*Fédération
Aéronautique
Internationale*

of the **Plenary Meeting** of the
FAI Aeromodelling Commission

To be held in **Lausanne, Switzerland**
on 3 & 4 April 2020

CIAM PLENARY MEETING 2020

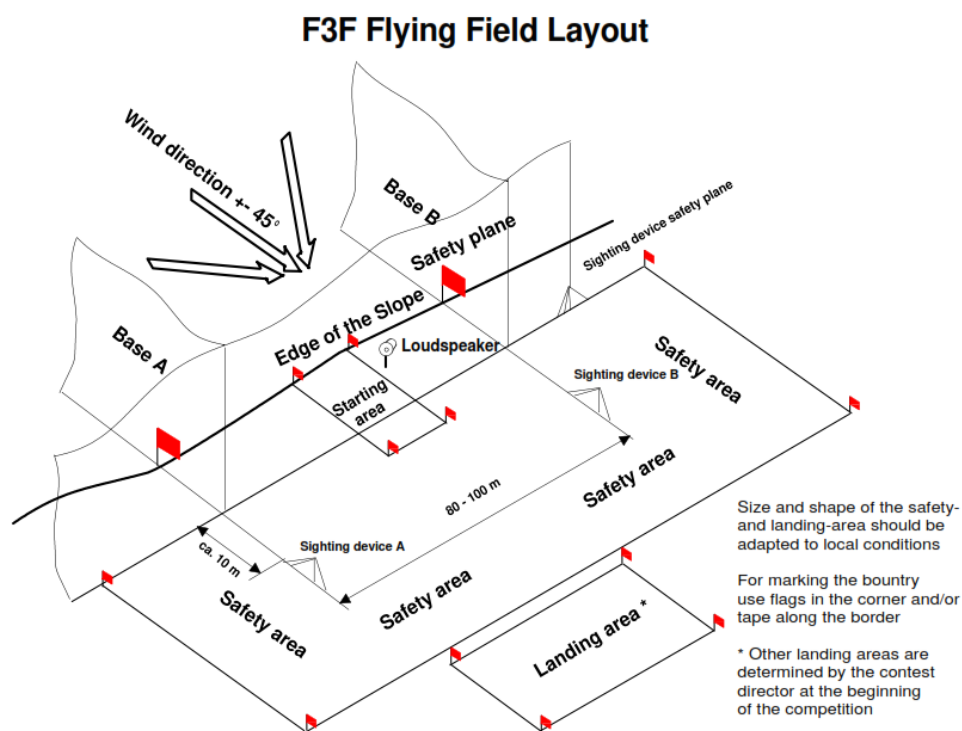
Delete the word 'follows' and replace the diagram with the following :

Reason: The recommended distance between the officials at the sighting device at Base A and Base B and the safety plane is 10 m. See new sketch.
